STATEMENT OF RESPONSE TO AN BORD PLEANÁLA'S CONSULTATION OPINION

IN RESPECT OF A
PROPOSED RESIDENTIAL DEVELOPMENT
AT ACADEMY STREET NAVAN, CO. MEATH
NOVEMBER 2019

Client:	Coindale Ltd.
Project Title:	Navan Belmont SHD
Document Title:	Statement of Response to An Bord Pleanála’s Consultation Opinion
Document No:	17160SRABP

Figure 2.2 – Meath County Development Plan 2013-2019, Navan Town - Land Use Zoning Map

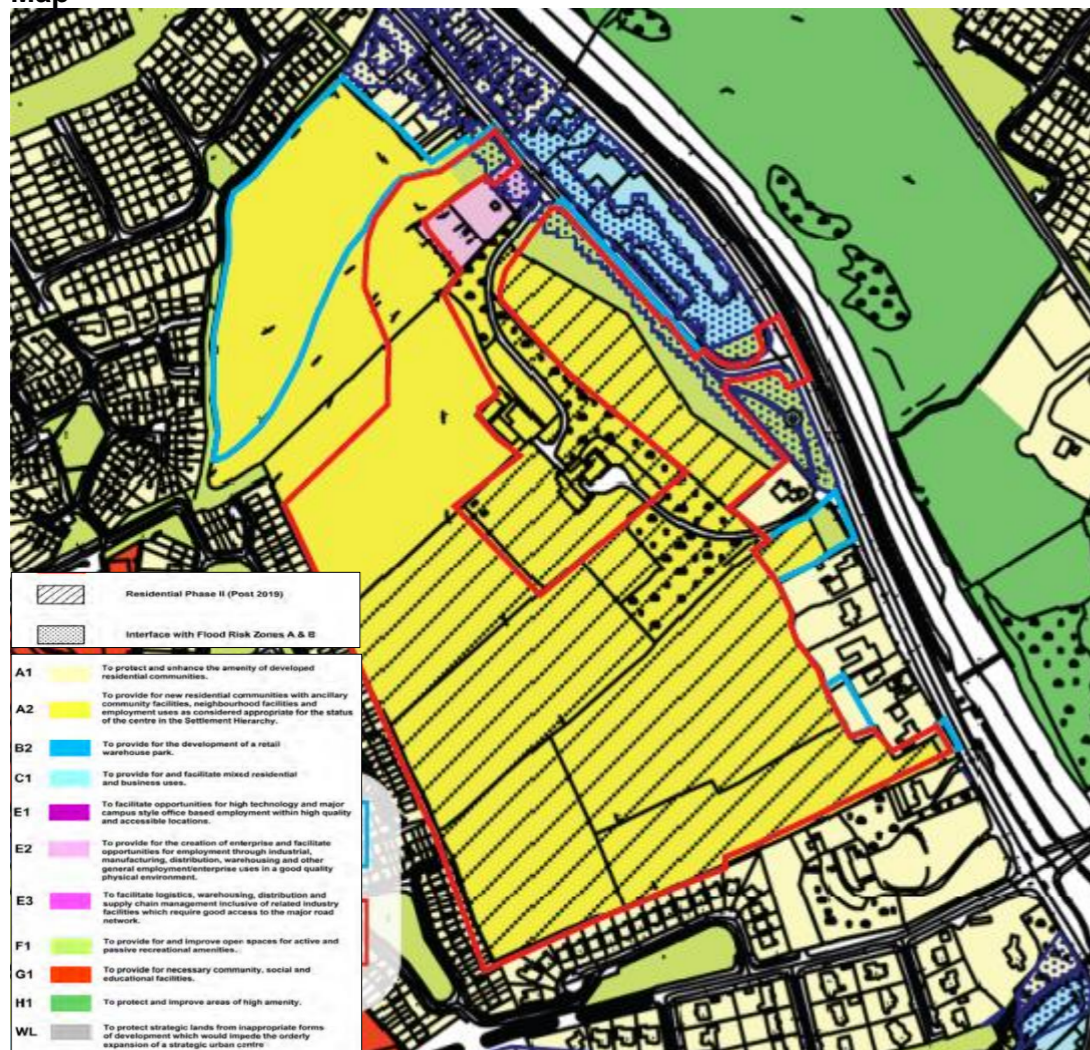
“Further consideration of the documents as they relate to the phasing of residential zoned lands in the Navan Development Plan (Objective CS OBJ 3 refers). This consideration, including a justification for any application for development, should have regard to, inter alia, the Navan Development Plan 2009 - 2015 as it relates to the phasing of residential development and, in particular, the quantum and location of Phase 1 lands within the Development Plan which remains undeveloped. This consideration and justification should also have regard to, inter alia, the 'Guidelines for Planning Authorities on Sustainable Residential Development in Urban Areas' (May 2009) as it relates to the sequential approach and phasing.

- 14 The majority of the application site is zoned as A2 "New Residential", under which zoning residential development is permissible.
- 15 The A2 zoning has an objective to 'provide for new residential communities with ancillary community facilities, neighbourhood facilities and employment uses as considered appropriate for the status of the centre in the Settlement Hierarchy'.

- 16 The A2 zoned lands within the subject site are also subject to a phasing objective 'Residential Phase II Post 2019' under the Meath County Development Plan 2013-2019.

Figure 2.6 – Building Heights

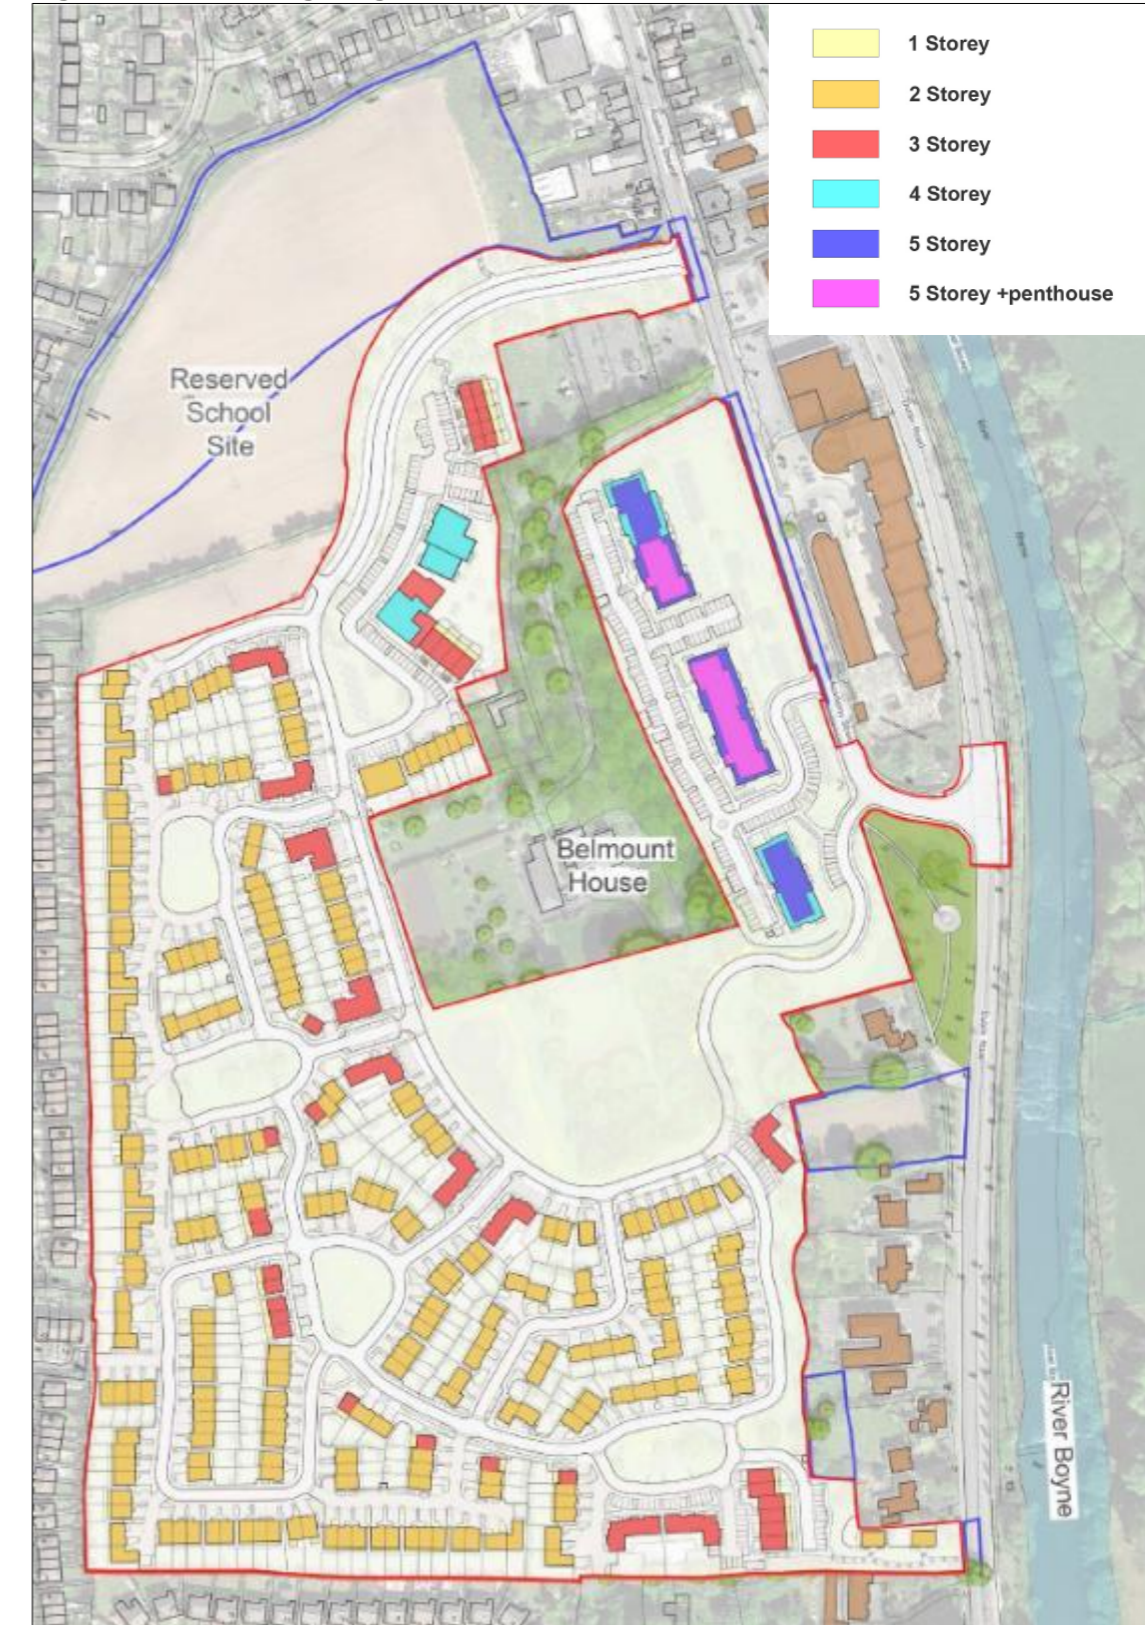
“Further consideration of documents as they relate to unit mix, building height, typology and layout of the proposed development particularly in relation to the 12 criteria set out in the Urban Design Manual which accompanies the 'Guidelines for Planning Authorities on Sustainable Residential Development in Urban Areas' (May 2009), the 'Urban Development and Building Heights Guidelines' and the 'Design Manual for Urban Roads and Streets'. In addition to density which is addressed above, the matters of unit mix, the configuration of the layout and the architectural approach should be given further consideration. Further consideration of these issues may require an amendment to the documents and/or design proposals submitted.”

74 In response to this item the proposed unit mix, building heights, typologies and layout has been amended significantly.

75 In summary, the proposed mix has been amended to include a broader unit mix and typologies throughout the overall landholding. At, pre-application stage, the western portion of the subject lands contained predominantly 2 storey, detached and semi-detached houses, while Academy Street contained 3 no. apartment blocks in an appropriate urban edge, at this key location in Navan. The response is set out under the following headings:

Figure 2.10 – Flood Risk Areas

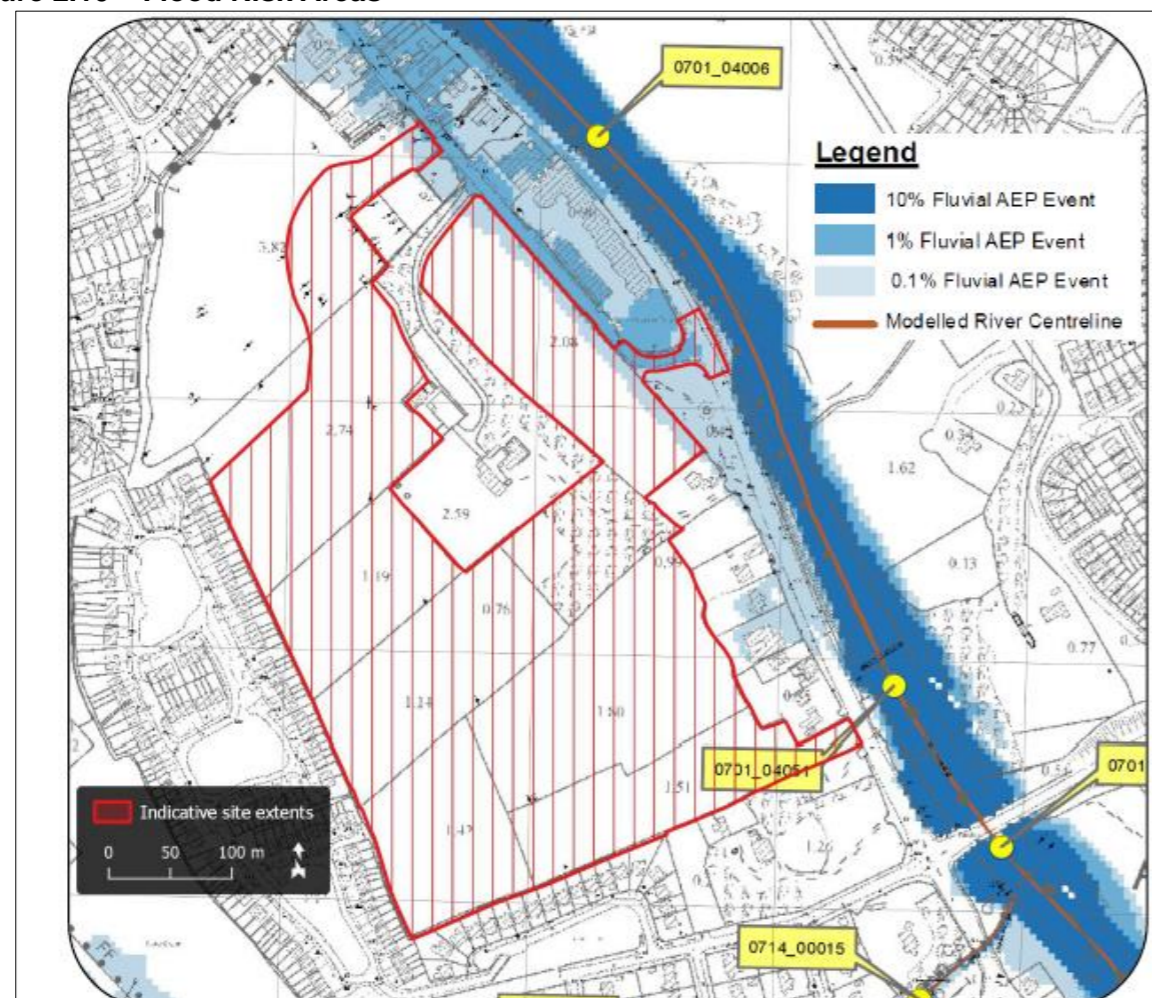
“Further consideration of the documents as they relate to Flooding, specifically in relation to the Planning System and Flood Risk Management Guidelines for Planning Authorities, issued by the Department of the Environment, Heritage and Local Government and the OPW.”

221 In response to the above we refer the Board to the Site Specific Flood Risk Assessment prepared by CS Consulting Engineers in accordance with *“The Planning System and Flood Risk Management Guidelines for Planning Authorities”* (2009).

222 The majority of the subject site is located in Flood Zone C with a small portion located in Flood Zone B (along Academy Street).

Figure 3.3 – Site Sections (CCK Architects)

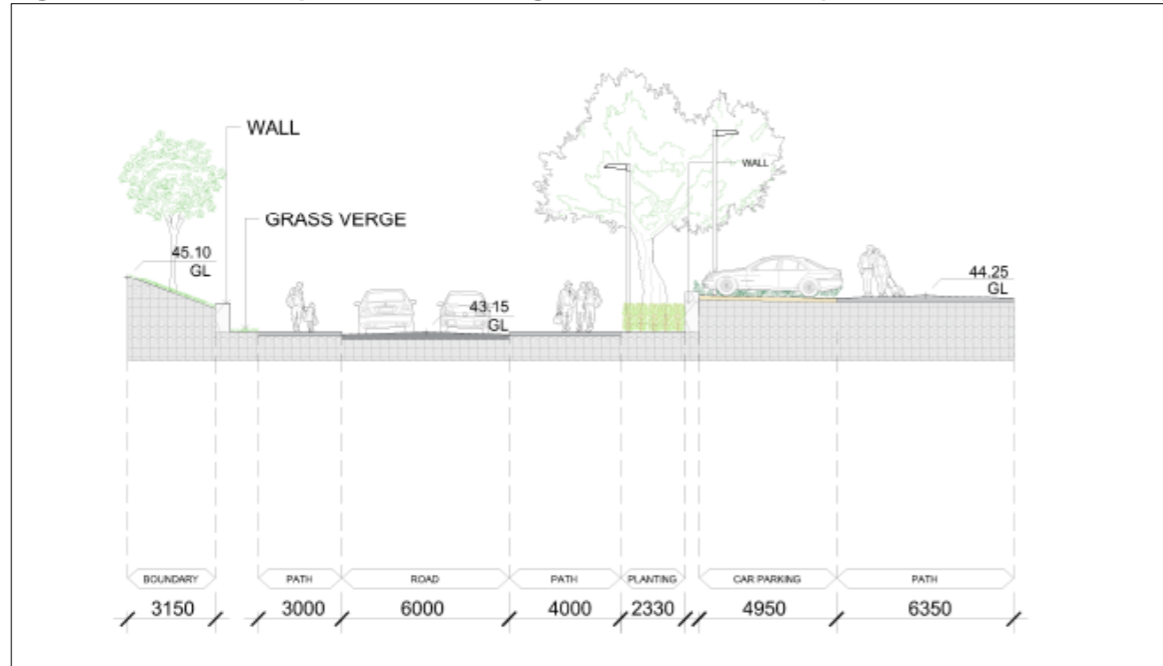
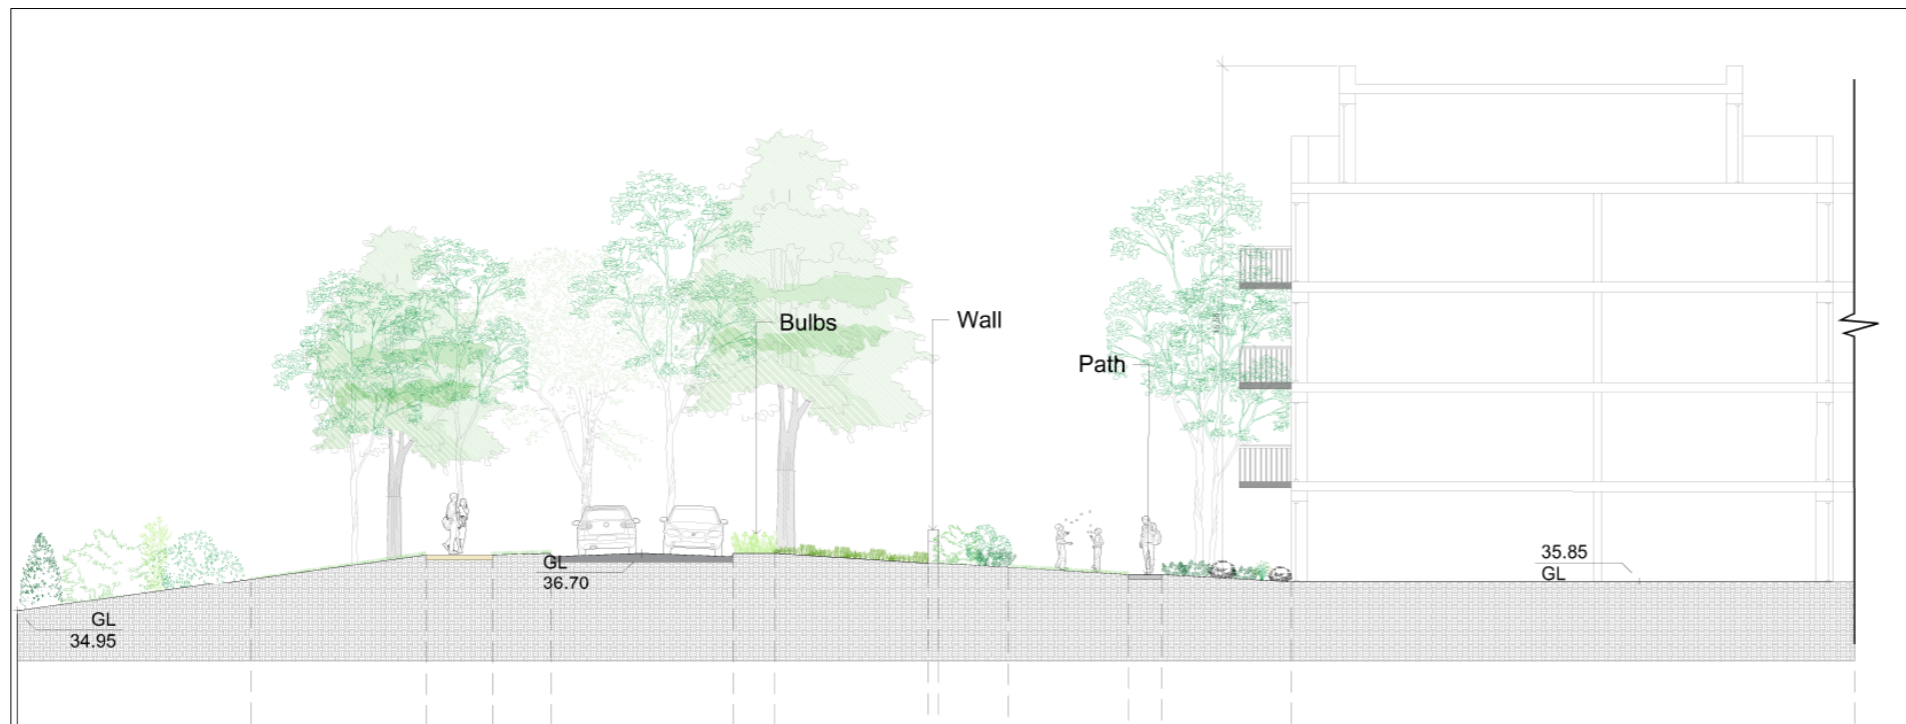
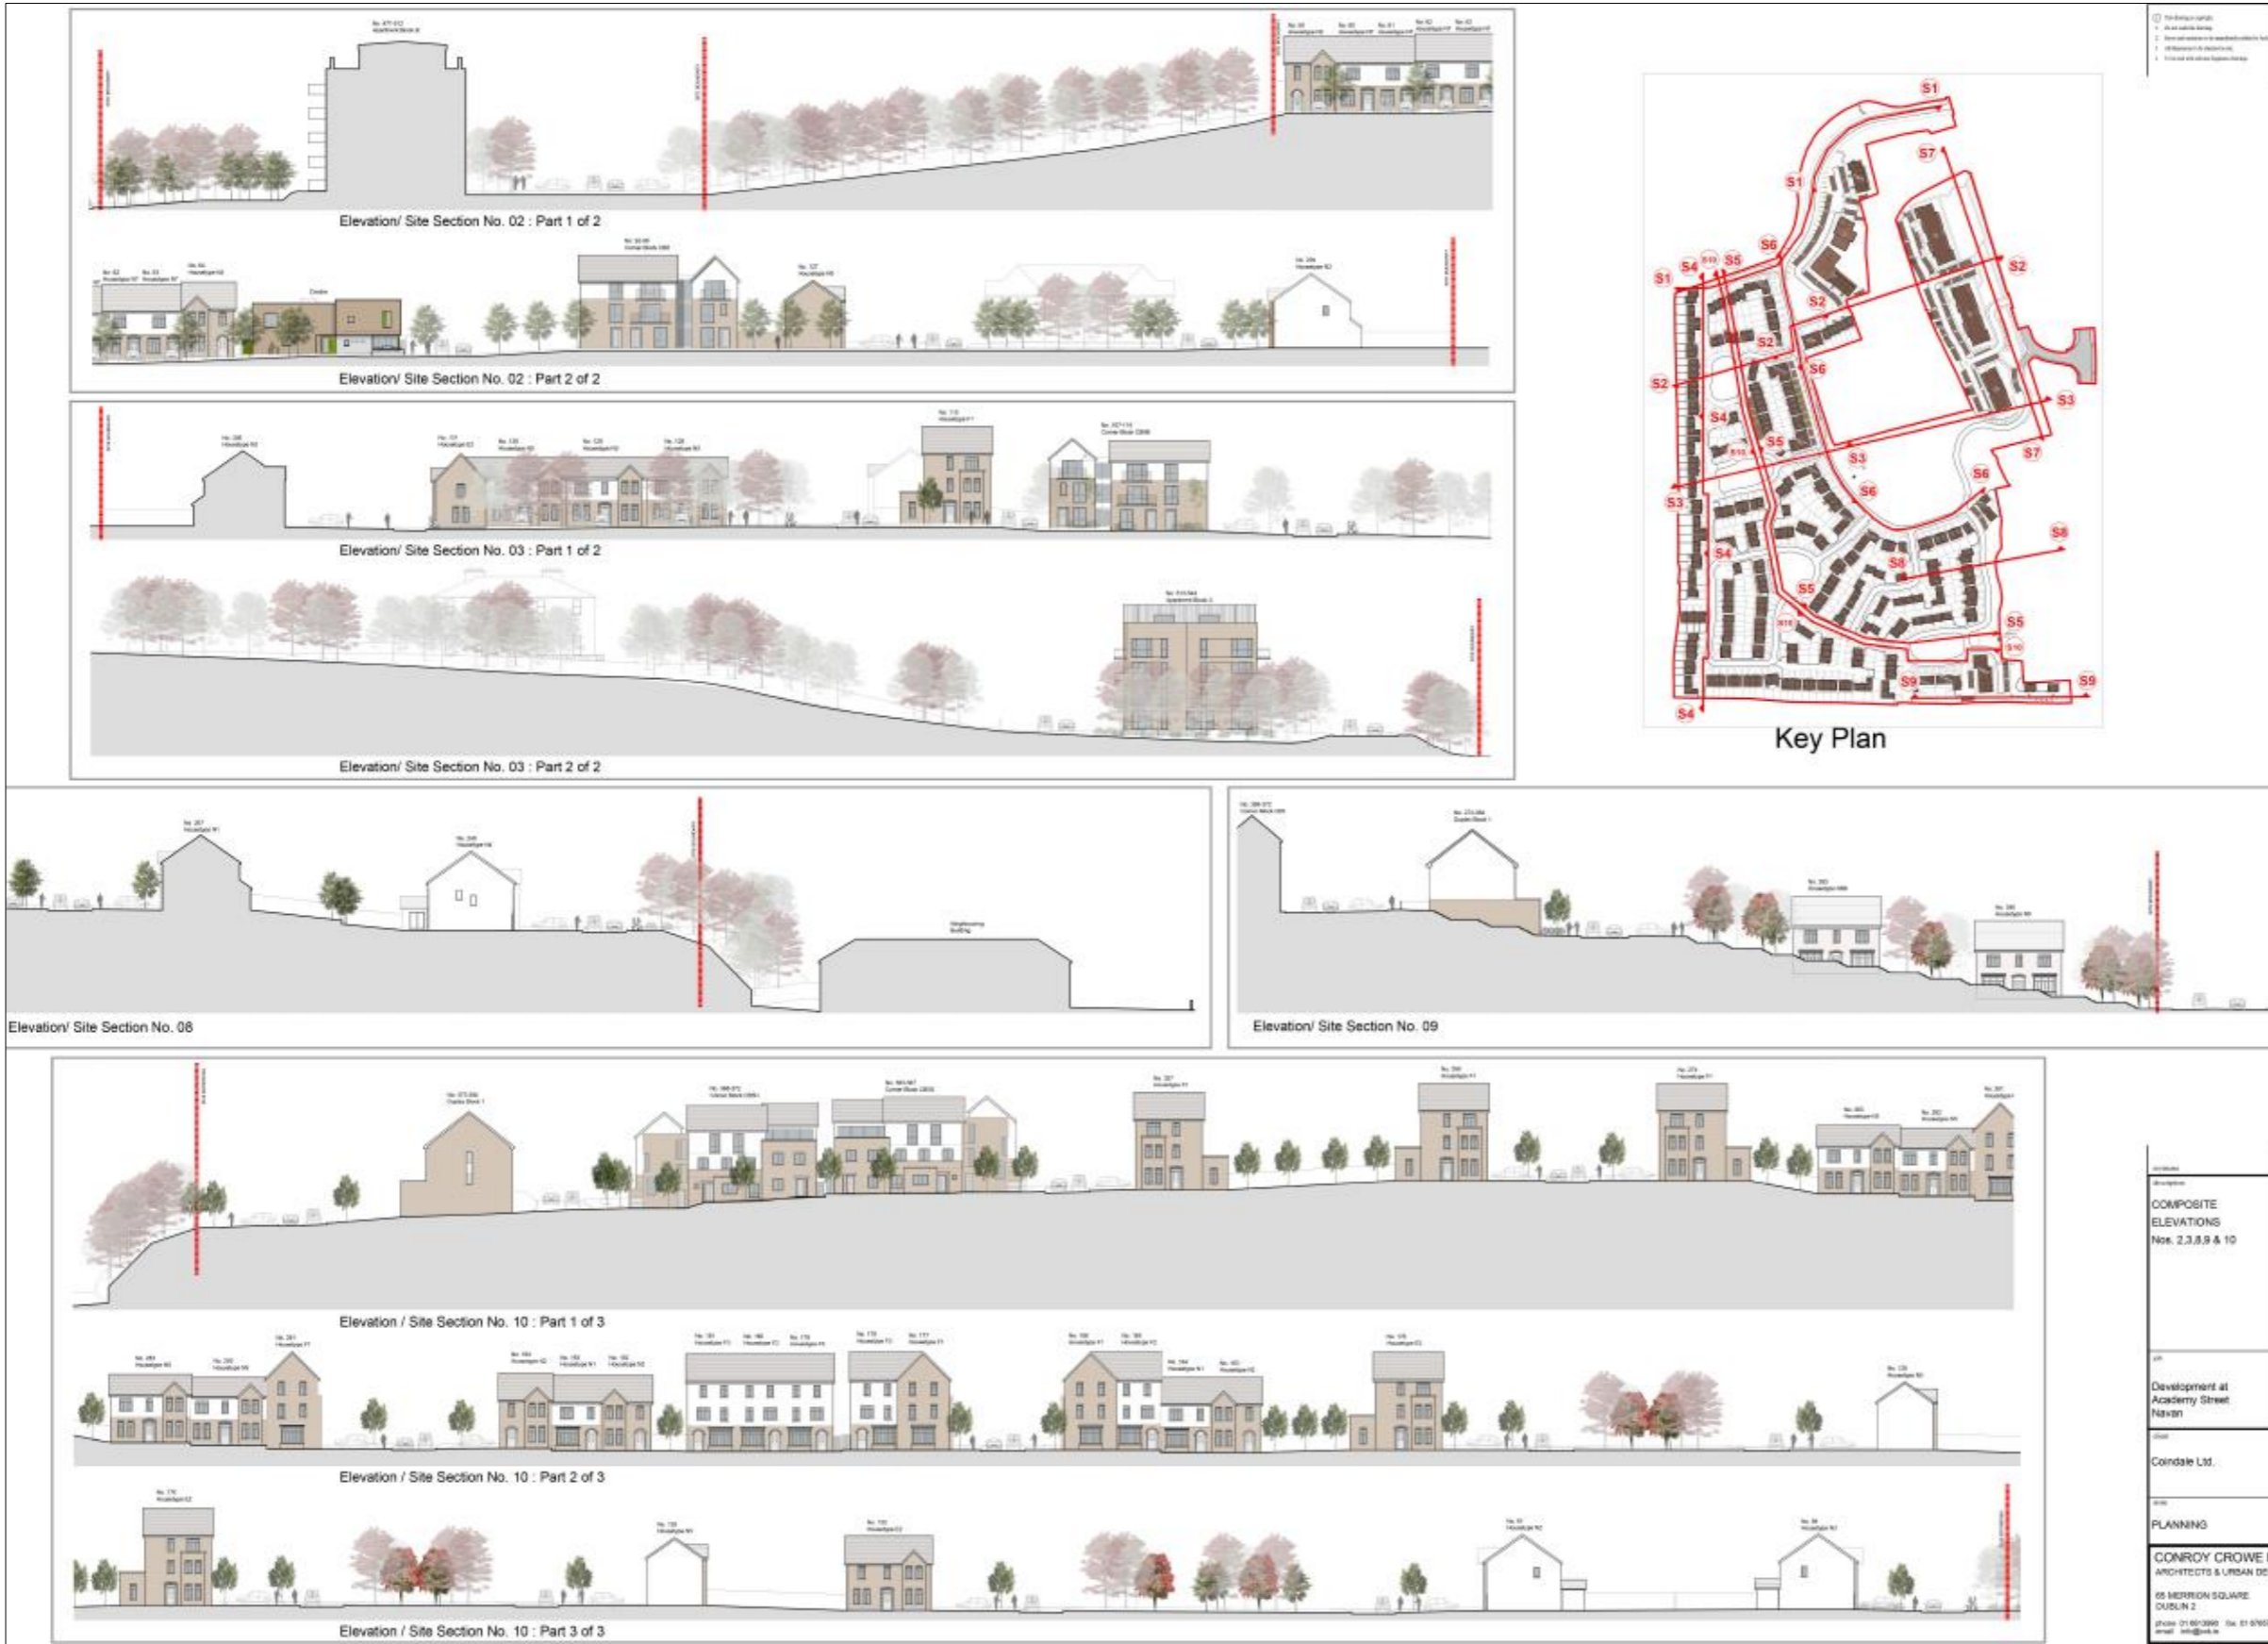
- *Detailed of proposed earthworks to address level differences on site, including detail of proposed cut and fill works and resultant gradient / retaining features.*
- *Design of the proposed surface water management system including attenuation features and cross sections of all SuDS features proposed on site in the context of surface water management on the site.*
- *Details of all materials proposed for buildings, open spaces, paved areas, boundary and retaining walls.*

12 Further section detail of the road layout is provided on CSR Landscape Drawing (18221-2-201) as follows.
